PLANNING COMMISSION REGULAR MEETING

Tuesday, September 20, 2022 at 7:00 PM

- 4. ZMA/SUP 2021-01 North Rock Harris Teeter Service Station:** The Applicant is applying for a Zoning Map Amendment and Special Use Permit to allow for a fuel service station in the North Rock Shopping Center located at 530 Fletcher Drive. The subject parcel was rezoned with a Master Zoning Plan in 1999. The request is to amend the Master Zoning Plan to include a fuel service station and seek a Special Use Permit for the use.
- 5. SUP 2022-4 Oak View National Bank Drive-Thru:** the Applicant is applying for a Special Use Permit to allow for a drive-thru to be located in a by-right bank at an empty parcel on the corner of Garrett Street and Waterloo Street (6984-04-7890-000).

TO: Planning Commission
FROM: Denise Harris, Planning Manager
RE: Zoning Map Amendment 2021-01/Special Use Permit 2021-01
Harris Teeter Fuel Station

Figure 4-1: 2021 Directional Distribution and Trip Assignment of Site Generated Trips.....24

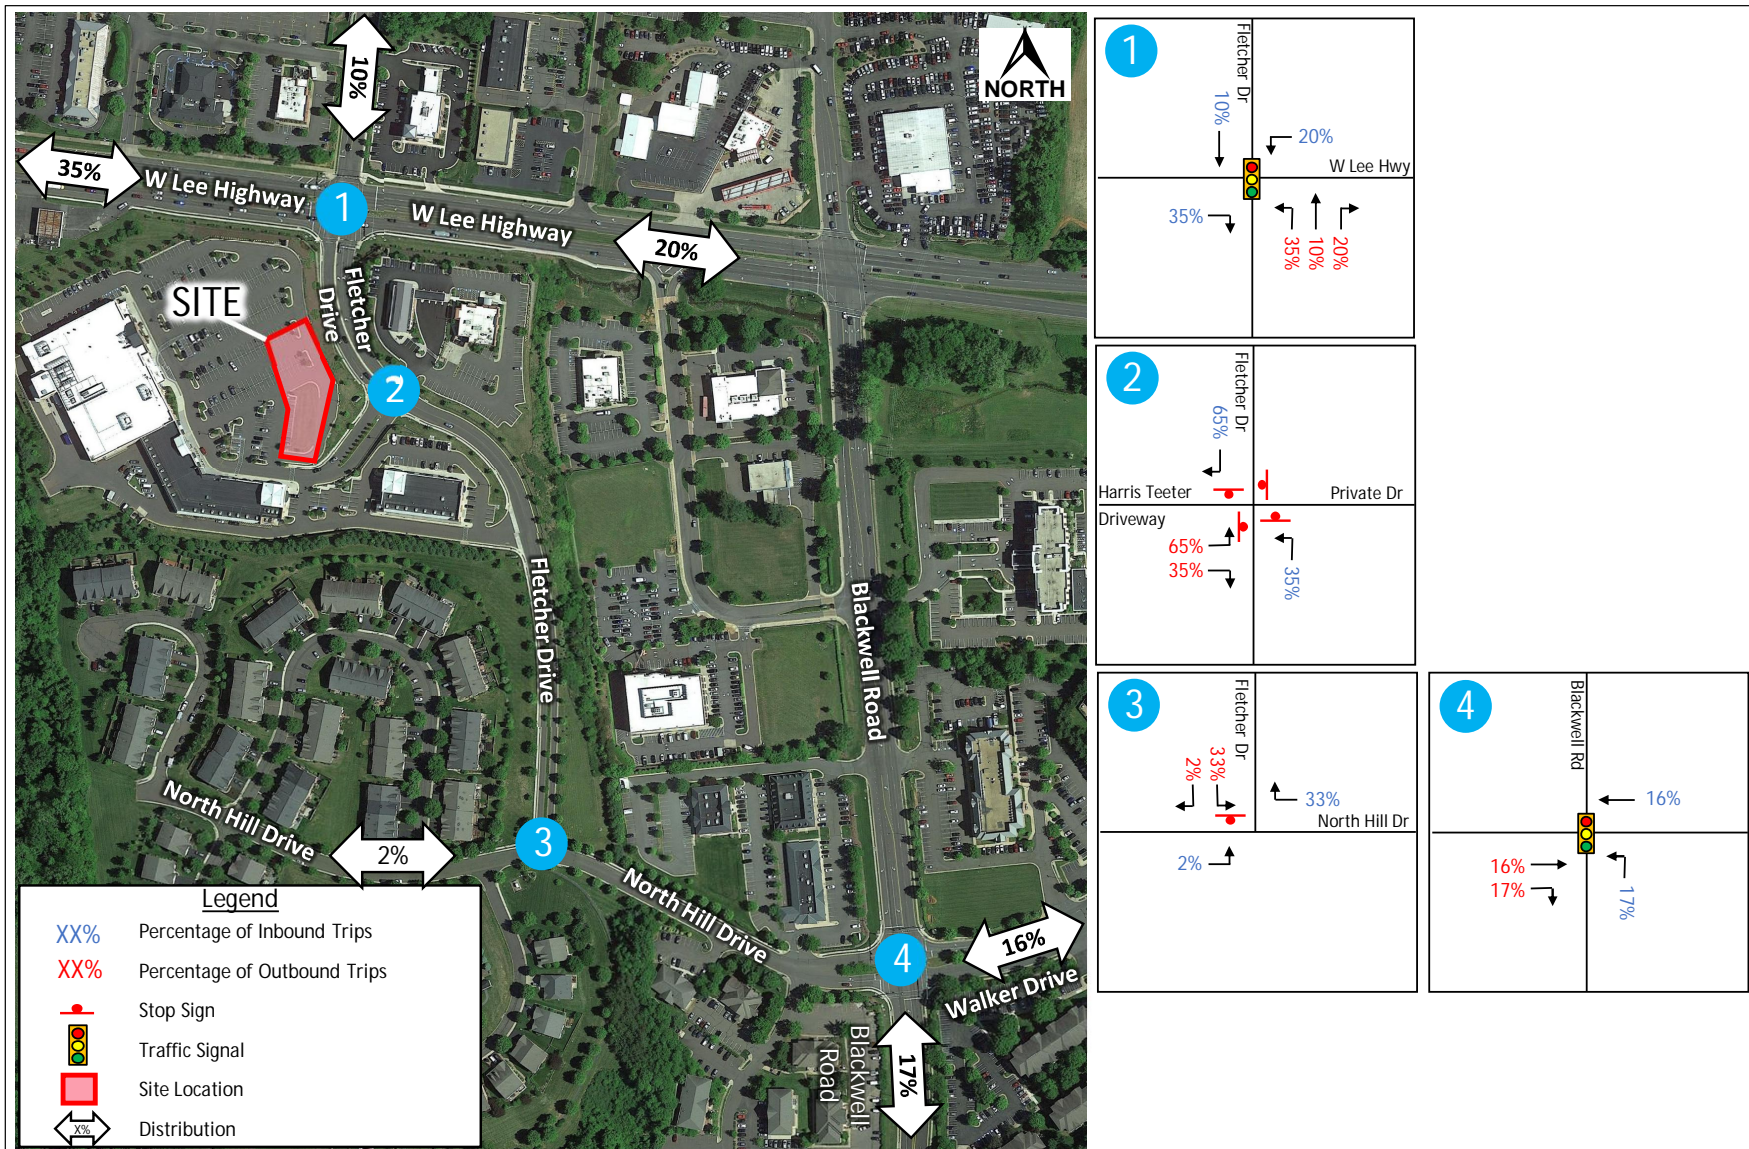
- The directional distribution in Figure 4-1 indicates 17% of trips will be assigned to the northbound left turn on Blackwell Road at North Hill Drive and 16% of trips will be assigned to westbound Walker Drive at Blackwell Road, but there are a higher number of PM peak hour trips (4) assigned to westbound Walker Drive than the northbound left turn on Blackwell Road (3) in Figure 4-2. The same is true in the opposite direction. We recommend swapping the volume of trips assigned to these movements to more closely match the assumed directional distribution.

Figure 4-3: 2021 Pass-By Peak Hour Trips26

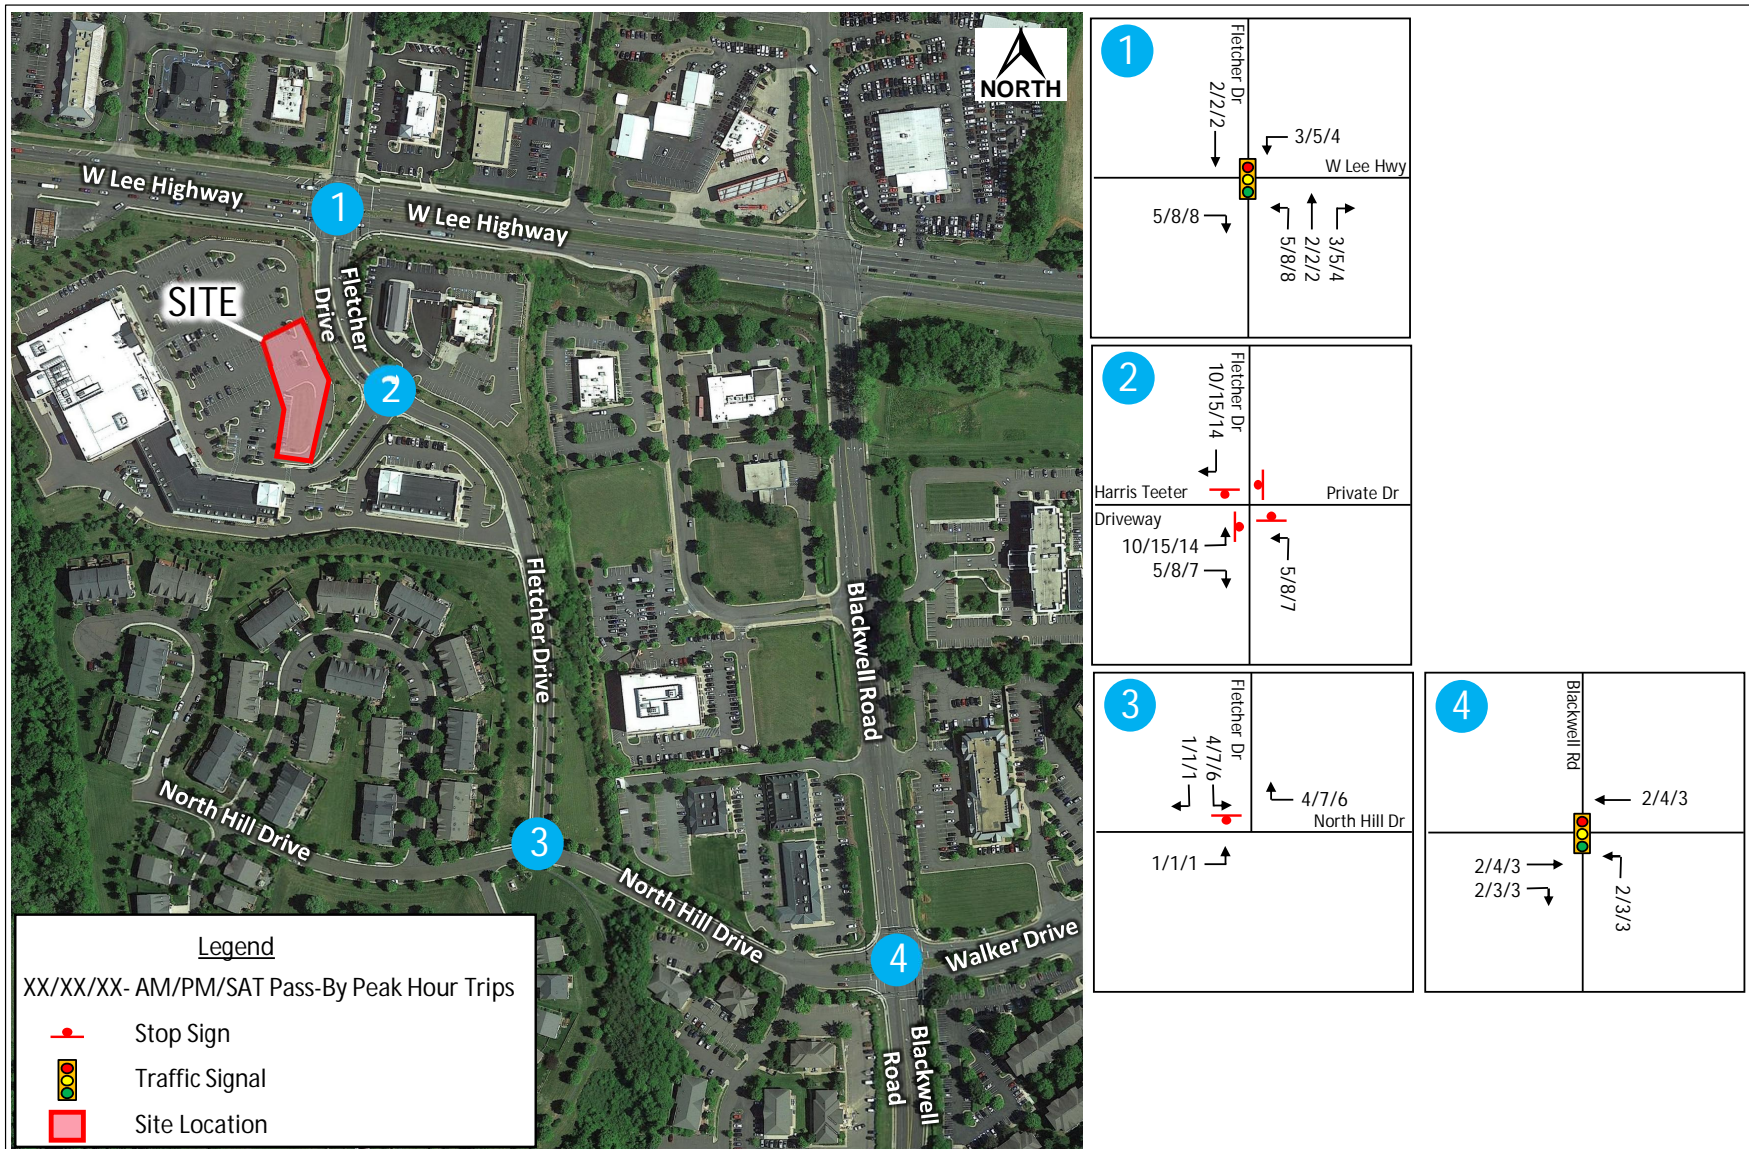
- Some of the pass-by trips shown in Figure 4-3 have been assigned as diverted trips from Lee Highway. Due to the low existing through volumes on Fletcher Drive near the site, we recommend that all pass-by trips be assigned as diverted trips from Lee Highway. Typically pass-by trips would represent no more than 15 percent of the total through volume on Fletcher Drive. The table below identifies the existing northbound through traffic volume on Fletcher Drive and the assumed pass-by percentage associated with the northbound movement, as well as the maximum recommended northbound pass-by volume:
